# Access Compliance Report

## Public Rights-of-Way

Intersection ID: 25436	Main Street: ROLLING_SKY_DR	Cross Street: SOUTHBRIDGE_FOREST_DR	Location: NW
ADA ID: 04C81CB19E45	Ramp Type: PerpDiag	Initial Pass/Fail: Fail	Overall Compliance: No
Codes/Mitigation Info/Possible Solution		Field Measurements/Component Compliance	
Severity Score: 13.75

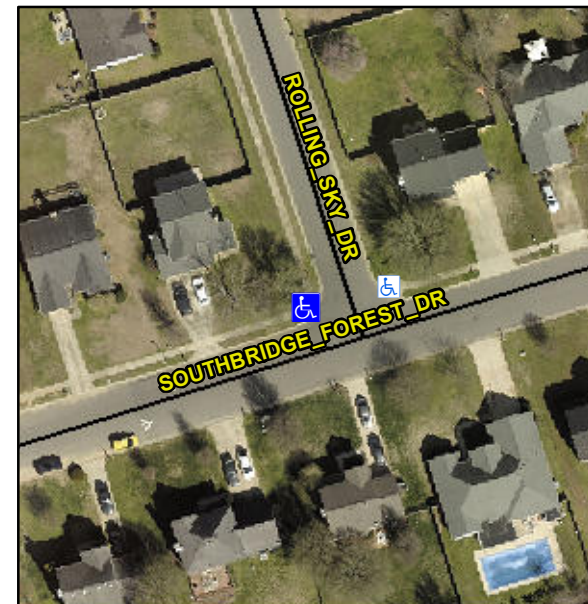
**Not Found, R304.2.2, R304.5.3**

Compliance	Description	Data	Compliance	Description	Data
N/A	Ramp Length (in)	50.0	No	Ramp Slope (%)	8.9
Yes	Ramp Width (in)	48.0	No	Ramp XSlope (%)	2.3
N/A	Flare Type LT	N/A	N/A	Flare Type RT	N/A
N/A	Flare Slope LT (%)	N/A	N/A	Flare Slope RT (%)	N/A
N/A	Flare Traversable LT?	N/A	N/A	Flare Traversable RT?	N/A
N/A	Landing Length (in)	N/A	N/A	DWS Provided?	N/A
N/A	Landing Width (in)	N/A	N/A	DWS Contrast?	N/A
N/A	Landing Slope (%)	N/A	N/A	DWS Length (in)	N/A
N/A	Landing X Slope (%)	N/A	N/A	DWS Full Width?	N/A
N/A	Landing Curb? (Y/N)	N/A	N/A	DWS Offset (in)	N/A
N/A	Shared Landing?	N/A			
N/A	Gutter Ponding?	N/A	N/A	Gutter Slope (%)	N/A
N/A	Gutter Lip Ht (in)	N/A	N/A	Gutter X Slope (%)	N/A
N/A	Painted X Walk1?	No	N/A	Painted X Walk2?	No
	X Walk 1 Direction	To S		X Walk 2 Direction	To E
N/A	X Walk 1 Width (in)	N/A	N/A	X Walk 2 Width (in)	N/A
	X Walk 1 Slope (%)	4.5		X Walk 2 Slope (%)	1.8
	X Walk 1 X Slope (%)	2.1		X Walk 2 X Slope (%)	0.1

**Remove & Replace Curb Ramp With Two New Directional Ramps or Equivalent.**
